Technical product information

Topic	Bentayga - Front Park Distance Control - False Detection
Market area	Bentley: worldwide (2WBE),Hongkong-Macau (5HK)
Brand	Bentley
Transaction No.	2044189/1
Level	EH
Status	Approval
Release date

Figure 1.

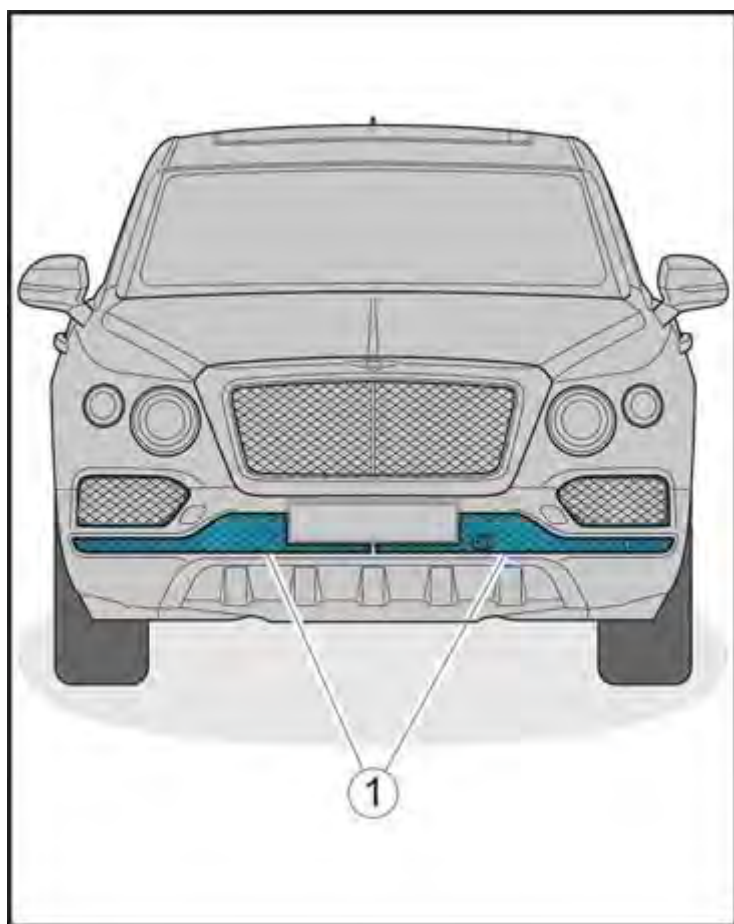
Park Distance Control sensor cavities are under size, this may result in false obstacle warnings.

From VIN 13149 - Manufacturing tooling change to ensure lower front grille cavity diameters are Eighteen and a Half Millimetres.

With a confirmed complaint of false Park Distance Control warnings from the front of the vehicle, remove the lower front Grilles – Items 1 - refer to **Repair Group 63 Front Bumper Grilles – To Remove and Fit** - figure 1.

Remove the Park Distance Control Sensors from each grille and measure the cavity diameter in two places. The cavity diameter should be 18.3 to 18.7 millimetres, if it is outside of these measurements the Grille should be discarded and replaced with a new part.
